MIL-F-85475(AS)
AMENDMENT 3
23 June 1995
SUPERSEDING
AMENDMENT 2
3 September 1986

MILITARY SPECIFICATION

FUZE, GUIDED MISSILE, FMU-141/B

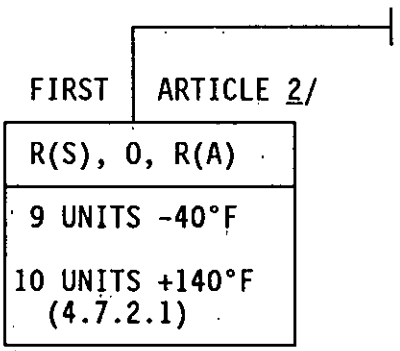
Figure 9, second horizontal line from bottom reading "6 PREPROD/1 INSPECT": Delete "1" and substitute "3". Figure 9, parallel to box labeled "R(S), S, O, R(A)," add the following:

Figure 9 NOTES: Add: "2/ Only mechanical operability tests shall be run at temperature shown."
